**Albuquerque
Metropolitan
Arroyo
Flood
Control
Authority**

Re: Sunrise Ranch Drainage Report (revised), 6/23/00
(L9/D6)

**Re: Revised Drainage Plan for Sunrise Ranch
Engineer's stamp 6-21-00 (J22/D68)**

**Re: Revised Grading and Drainage Plan for Sunrise Ranch Unit 2
Engineer's stamp 11-7-00 (L9/D6)**

**FIGURE 3: SNOW VISTA BASIN
MANAGEMENT PLAN**

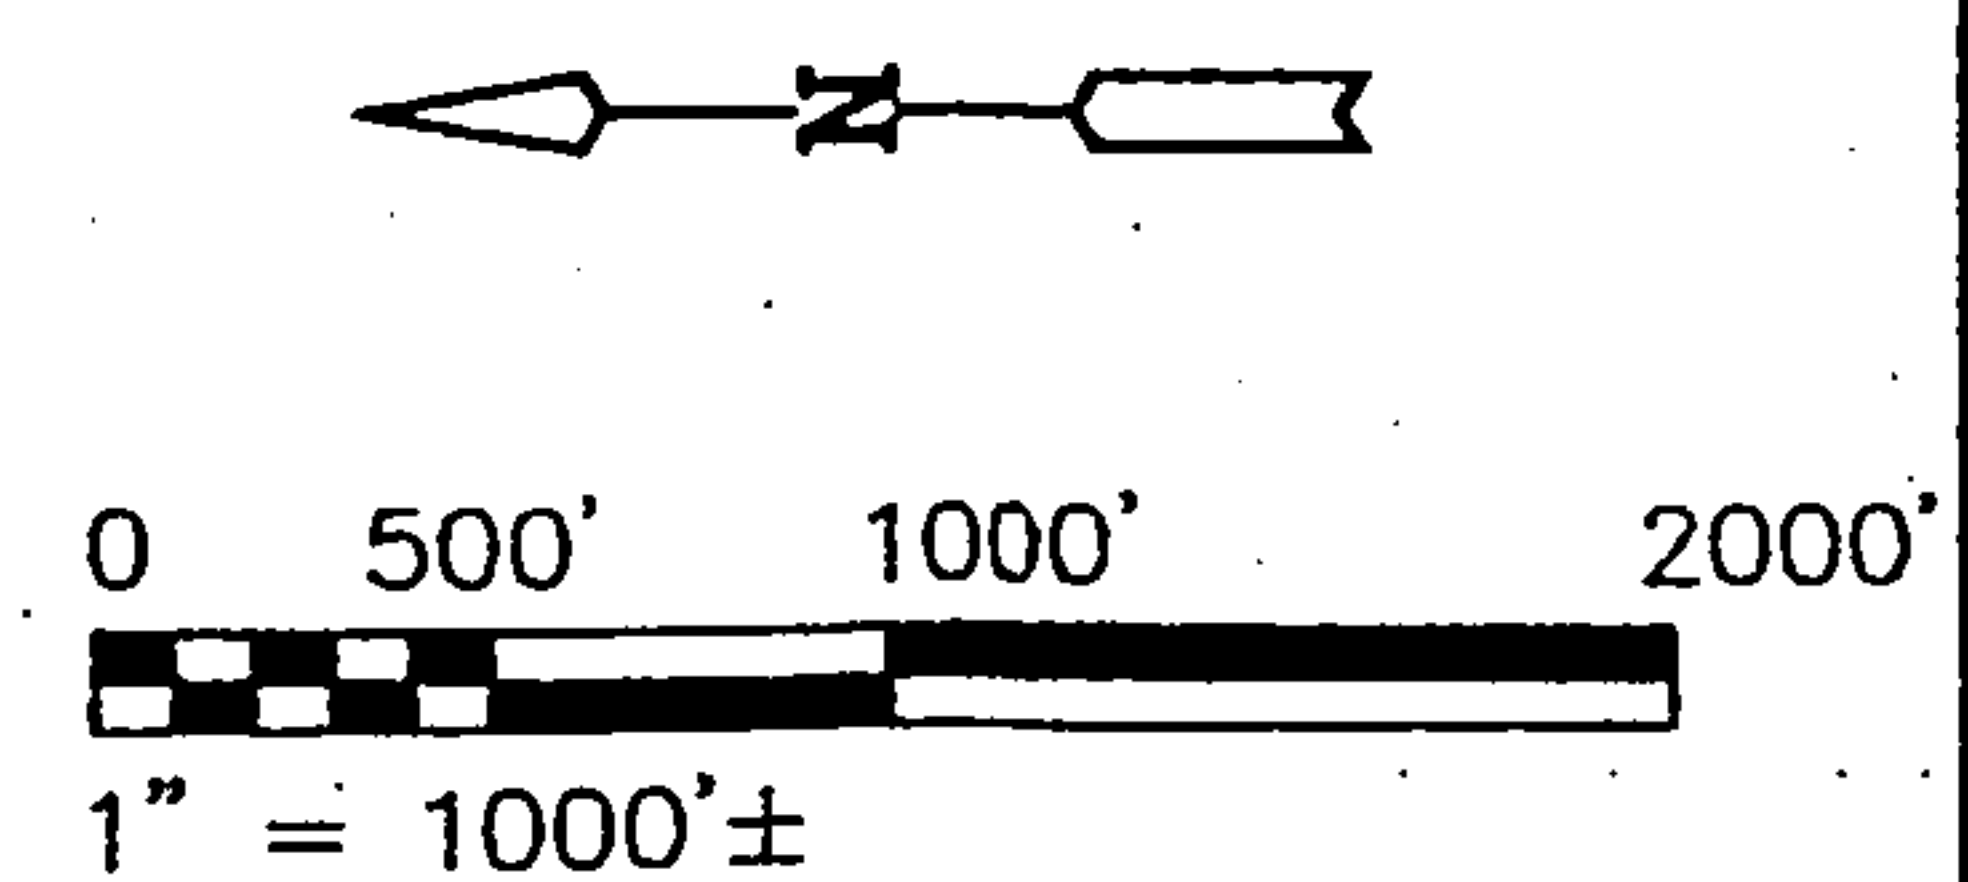
5. Show proposed AMAFCA floodplain easement (to HGL) on figure with contours.
6. Sub-basin 200 is clearly in the 1.29 cfs/acre constraint area shown in Figure I-2 (your figure 3) of the Amole-Hubbell DMP.

According to the Amole -Hubbell Drainage Management Plan there is no discharge constraint to the Snow Vista Sedimentation Pond for Subasin 200 of which the western most portion of our site is a part.
